T ECHNICAL INFORMATION

Subject ▶ Elimination of Sleeve 7, and Modification on Crank Shaft

For Models ▶ HR4000C

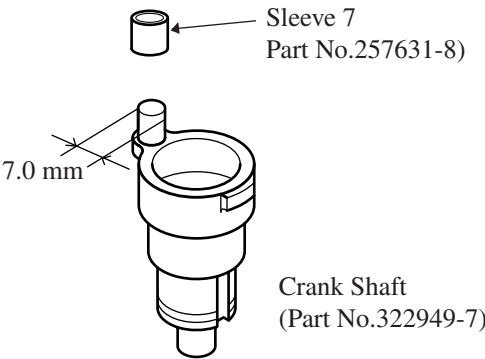
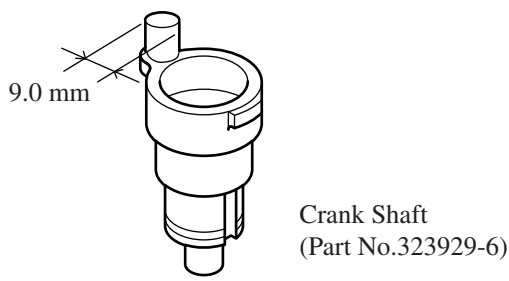
▶ Current	▶ New
 <p>Sleeve 7 Part No.257631-8)</p> <p>7.0 mm</p> <p>Crank Shaft (Part No.322949-7)</p>	<p>Sleeve 7 has been eliminated.</p>  <p>9.0 mm</p> <p>Crank Shaft (Part No.323929-6)</p>

Item No.	Current part		Q'ty	I/C	New part		Q'ty	Note
077	Sleeve 7 257631-8		1					↑ Interchangeable as a set. ↓
060	Crank shaft 322949-7		1	No	Crank shaft 323929-6		1

HR4000C : From serial No.94394E (June, 1999)
